In response to the Office Action mailed October 6, 2004, Applicant respectfully requests the Examiner to reconsider the above-captioned application in view of the foregoing amendments and the following comments.]

# ENGINE COUPLING SYSTEM Masanobu Yamamoto Unknown Atty Docket: FY.50687USOA

Annotated Marked-up Drawings Reply to Office Action of October 6, 2004

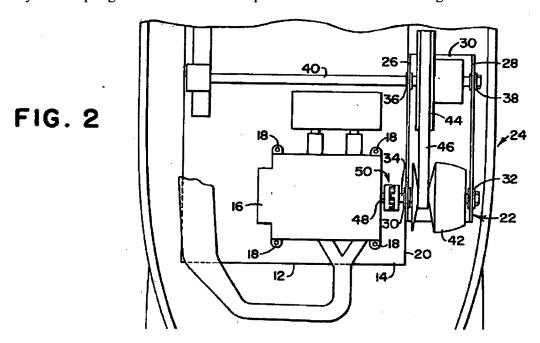
Leonard et al. '882 teaches a snowmobile having an internal combustion engine 16 mounted in a conventional manner. As shown in the enlarged portion of Figure 2 reproduced below, the crankshaft 48 of the engine 16 extends outwardly from the engine body to a coupling device 50 which is disposed on the *outside* of the engine 16.

A coupling 50 is also disposed on the outside of the engine 16. The coupling 50 connects the end of the crankshaft 48 with another shaft 34. The shaft 34 is supported by bearings 30 which are also disposed on the outside of the engine 30. In particular, the bearings 30 are supported by a wall 20 which forms a portion of the frame 12 of the snowmobile. Thus, it is crystal clear that the shaft 34 is *completely outside* of the engine 16 and is in fact supported by the bearing 30 mounted *on the frame* of the snowmobile and by the coupling 50 which is also disposed *completely outside* of the engine 16.

Nowhere does Leonard et al. '882 teach or suggest such an arrangement of a coupling system being mounted in a crankcase of an engine. Rather, as shown in Figure 2 of Leonard et al. '882, as noted above, the driven shaft 34 of Leonard et al. '882 is supported by bearing 30 that is mounted to a sidewall 20 of the frame 12 of the snowmobile. Thus, applicant submits that Claims 1 and 10 clearly and non-obviously define over the Leonard et al. '882 reference.

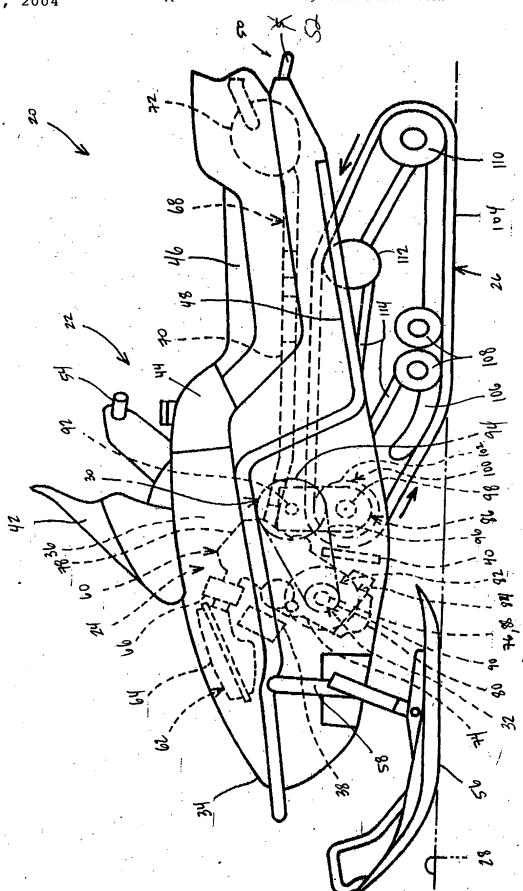
In Figure 1, please change reference numeral "5" to "52".

In Figure 3, please delete the reference numerals "62, 64" and the lead line associated therewith.

The drawings stand objected to under 37 CFR § 1.84(p)(5) based on certain informalities. In response, Applicant has amended Figure 1 to change the reference numeral "5" to "52". Additionally, in Figure 3, Applicant has deleted the secondary use of reference characters "62, 64" and the lead line extending therefrom. Applicant has included herewith a marked up set of Figures 1 and 3 showing the changes noted above as well as replacement sheets including amended Figures 1 and 3.

The above changes are shown in red in the attached marked-up copies and replacement sheets containing Figures 1 and 3.
